FW: O8W-PM [redacted] - Bucks Creek 1101 Phase 1,2&3 -  
Pre-Engineering Meeting

Subject: O8W-PM [REDACTED] - Bucks Creek 1101 Phase 1,2&3 - Pre-Engineering Meeting

PM [REDACTED] (Phase 1)

# Bucks Creek 1101- PM# [REDACTED] Overview Map

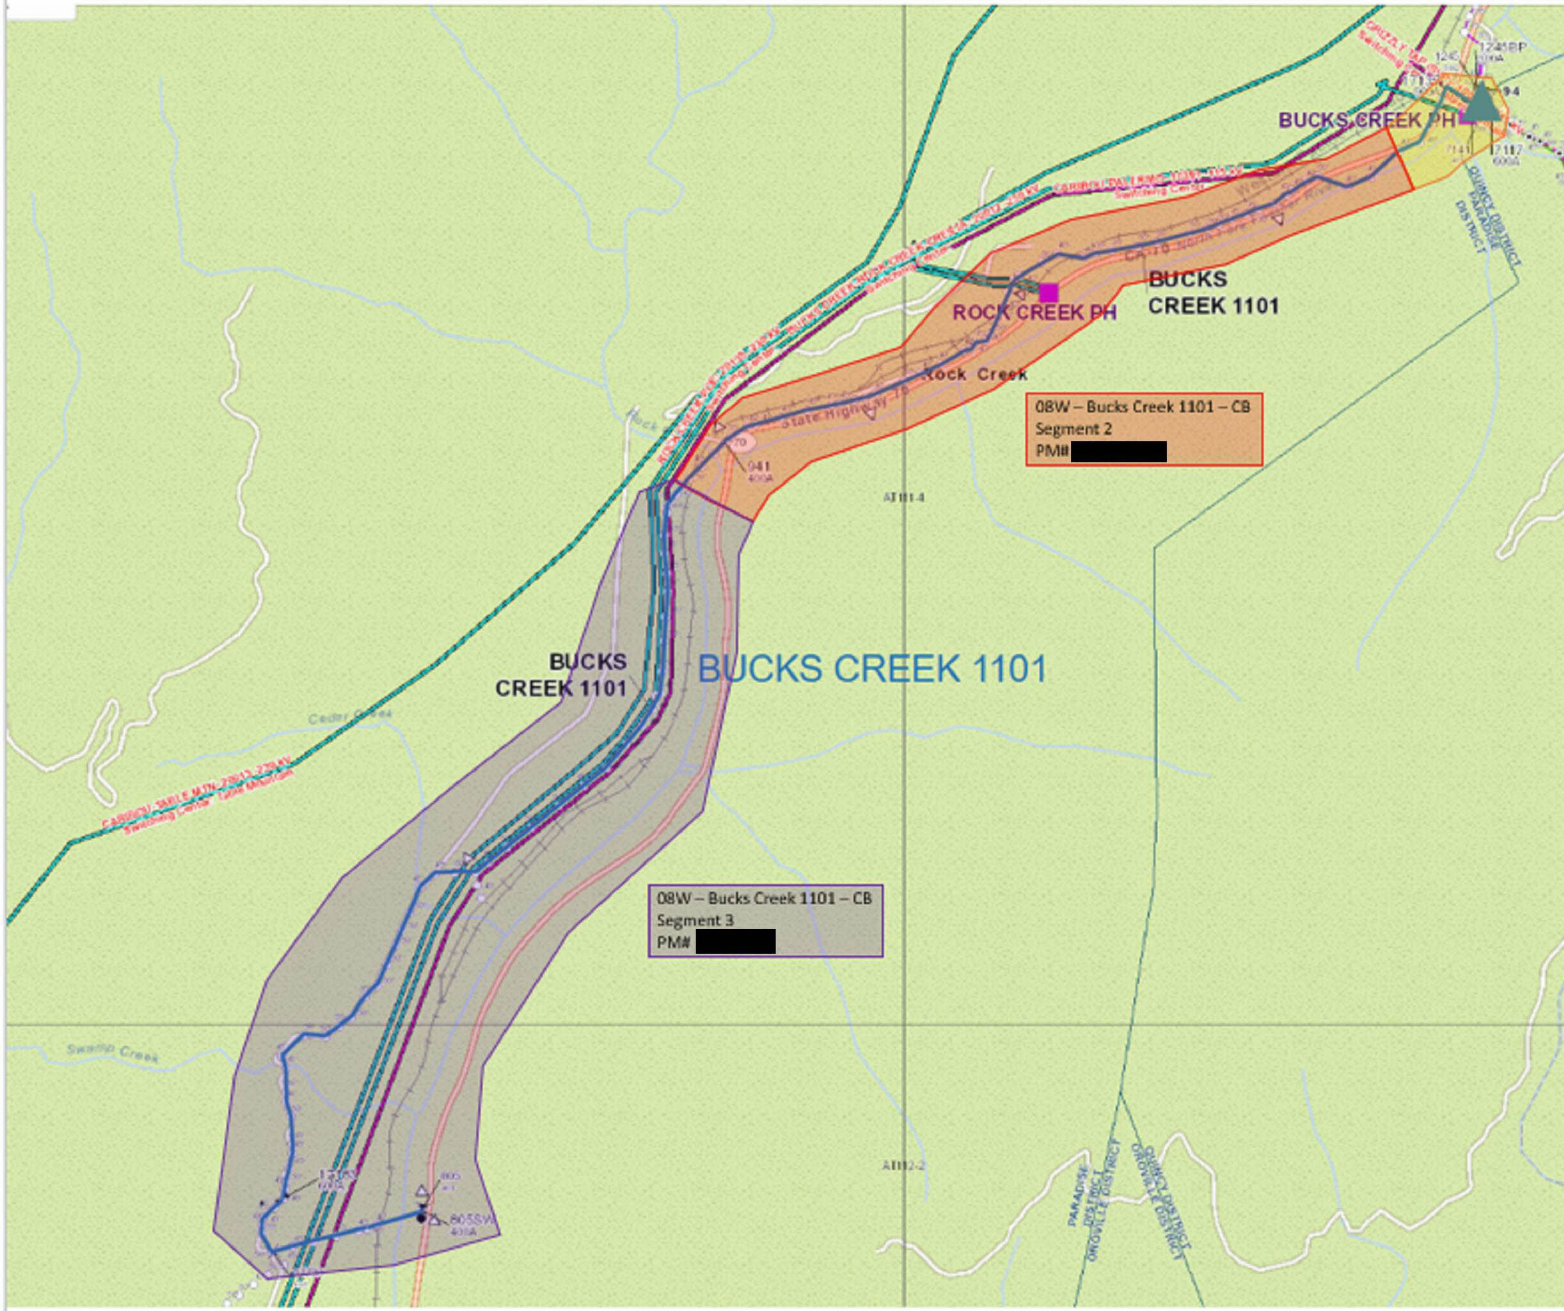
For Bucks Creek there is quite a bit of work surrounding Hwy 70 and we will need a Land Department Base Maps prepared for all 3 Orders. This will delay the EOD dates until these can be developed and provided to the Vendor... We will also need answers to the questions outlined by [redacted] below...
